## Turbo HD DVR V3.4.60 build160607 Release Notes (2016-6-15)

<b>Firmware Basic Information</b>	Firmware Version:	V3.4.60 build160607
	SDK Version:	V5.2.1.5 build20160506
	Play Library (PlayCtrl.dll)	6.0.0.4
	player	7.3.0.74
	Web version	V4.0.1 build160523
	Client version	V2.4.6.18 build20160531

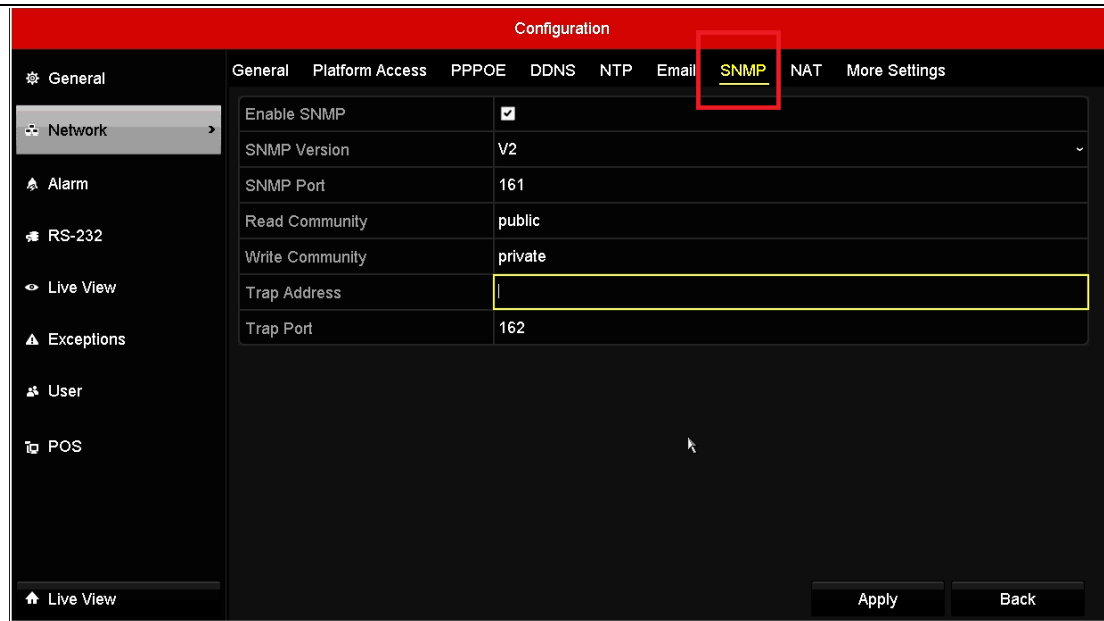
- iii. Support access of IP cameras up to **8MP**; support access of **H265** stream IP cameras.
- iv. Newly support raid **more than 16TB** for 73/81/90HUHI-Fx/N. For old models DS-9000HQHI-SH.
- v. Newly support hot-swappable HDDs
- vi. Optimize the GUI of soft keyboard which distinguish the upper case from lower case. In the previous version, it was all upper case. Just by one left-clicking the , it will switch the letter case.

Lower case

Upper case
